**CITY OF KIRKLAND**

**DESIGN RESPONSE CONFERENCE**

**STAFF ANALYSIS**

**File No:** DRC12-00001  
**Project Name:** Transit Oriented Development at South Kirkland Park and Ride  
**Applicant:** Polygon NW  
**Project Planner:** Janice Coogan, Senior Planner  
**Date:** March 7, 2012  
**Meeting Date and Place:** 7:00 p.m., March 19, 2012  
City Hall Council Chambers  
123 5<sup>th</sup> Avenue, Kirkland

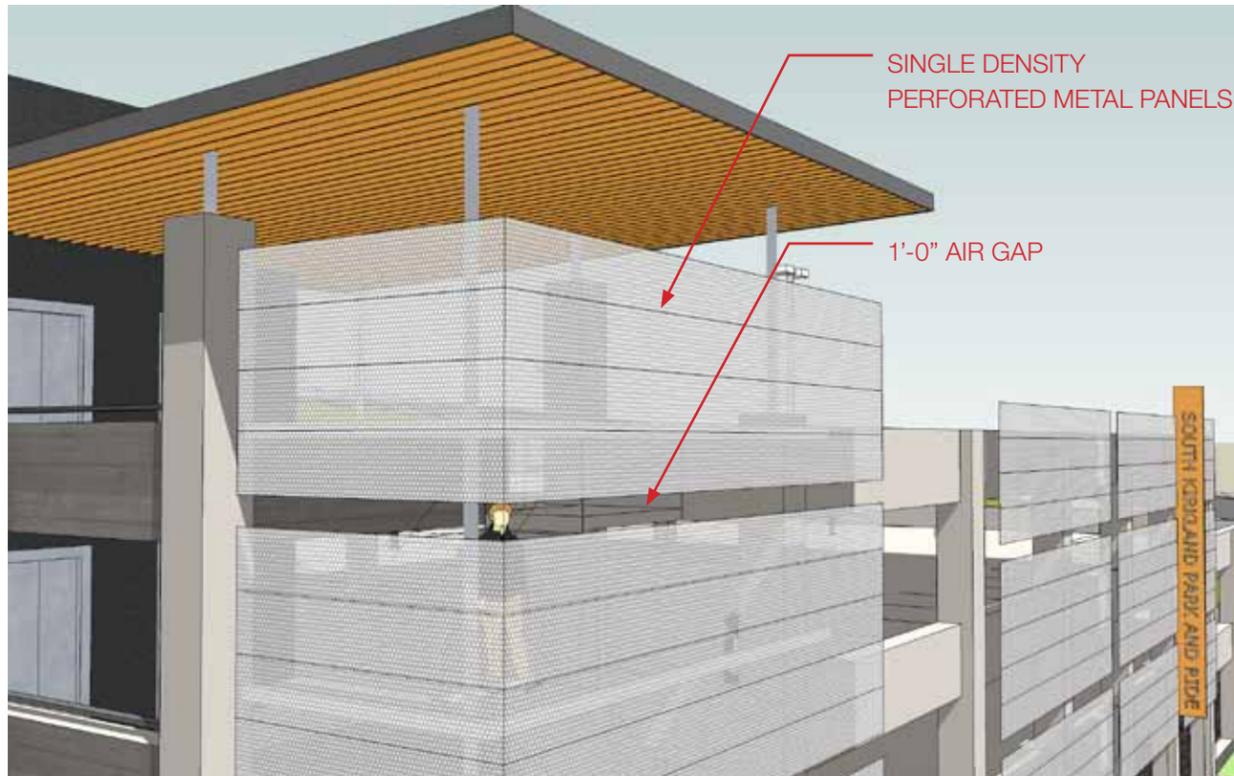
Additional Staff Comments- Staff would like to clarify the front yard setback requirement along NE 38<sup>th</sup> PI as it relates to the location of the property line if property is dedicated or a public access easement is accepted over the proposed sidewalk (see KZC 110.52).

In this case, after dedication, the new property line would be located in several areas of the site at the back of the sidewalk and therefore, the parking garage podium would need to be setback 10' from the sidewalk. The Planning Director is not comfortable making an interpretation at this time whether an easement or dedication is appropriate without first hearing from the Design Review Board that the portions of the parking garage (or non retail portions of the project) along NE 38<sup>th</sup> PI meet the intent of the design guidelines.

*With these changes, the design team has: (1) maintained the proposed guest parking along NE 38<sup>th</sup> Place (2) maintained a 10' setback from the sidewalk to the exposed portions of the building garage, (3) incorporated a ground floor retail space with direct pedestrian access, (4) preserved a sight distance corridor for the new driveway access at the south west corner of the community, (5) maintained landscaping along the base of the exposed podium base structure to connect to the midblock pedestrian corridor, and (6) added architectural random board form accent treatment to the concrete base to tie to the architectural character of the transit orientated community.*

*To accomplish these objectives, the 10' sidewalk along NE 38<sup>th</sup> Place is proposed to be partially constructed within an easement granted to the City of Kirkland. See the attached P1 Plan exhibit which identifies in crosshatch extremely limited building service area encroachment into the 10' setback.*

TRANSIT GARAGE SCREEN DETAIL - OPTION 1

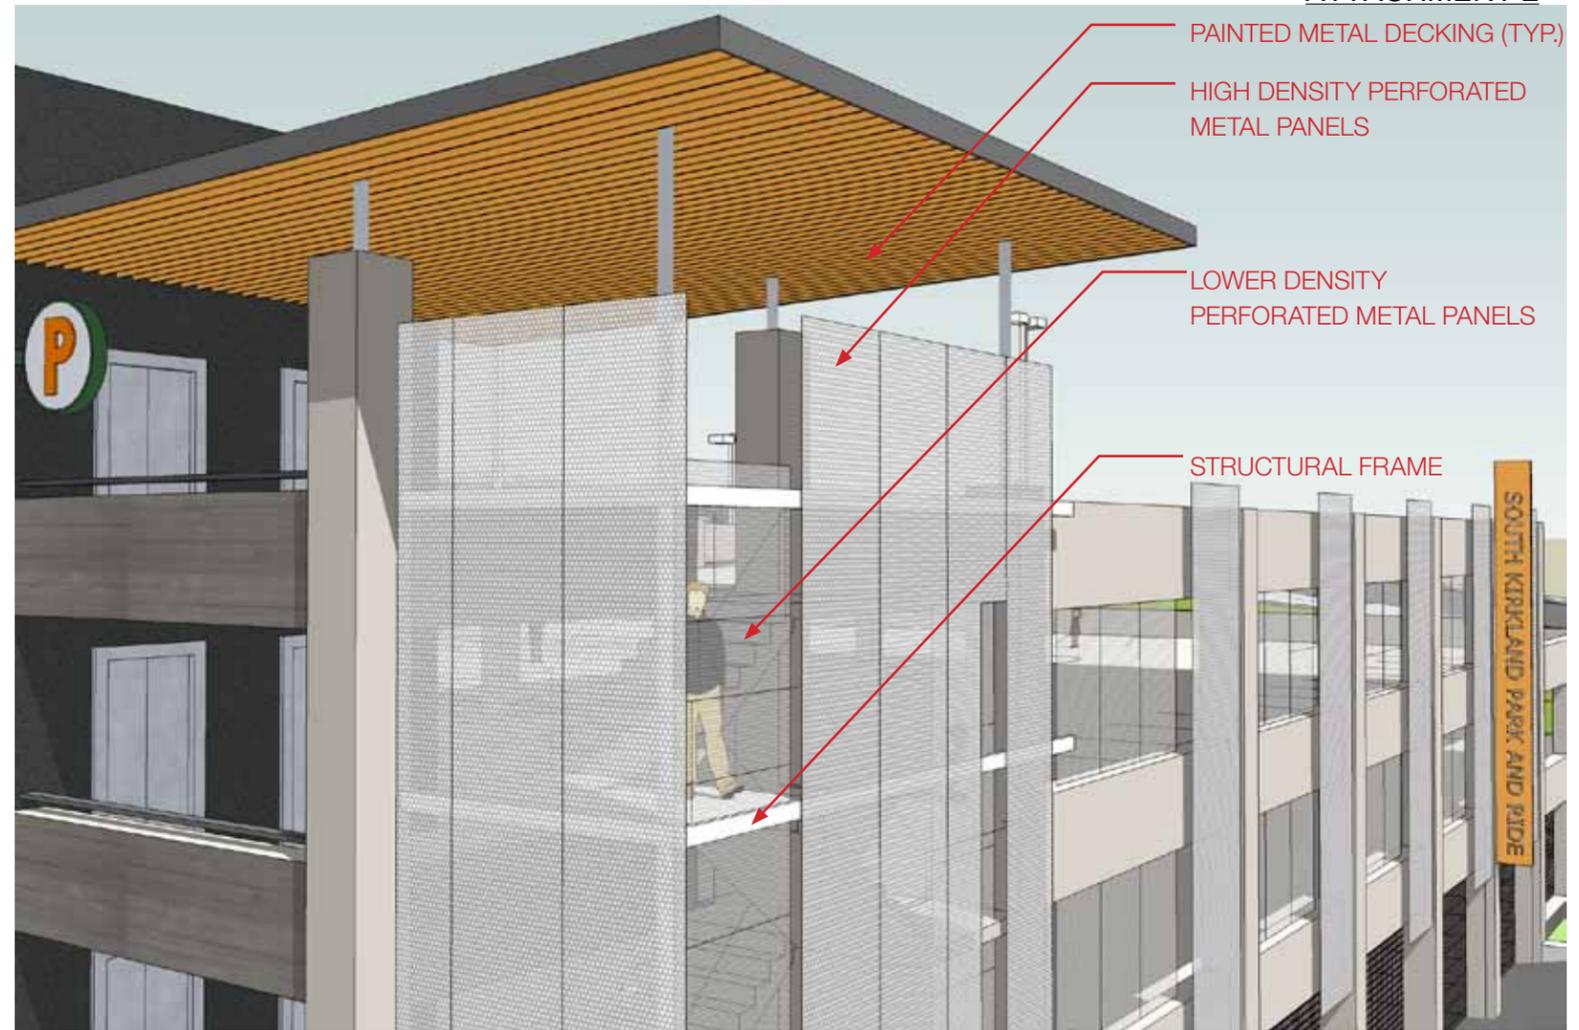
- Examples of other screening techniques and/or façade treatments in addition to green screens to screen the transit garage, especially at street axis view from 108<sup>th</sup> Avenue. They expressed concern about maintaining the vines growing on the screens.

Scheme 1 employs a monolithic perforated aluminum screen that wraps both the stair tower and the West façade of the garage. The screens are mounted horizontally on exterior of the vertical columns, masking the structure beyond.
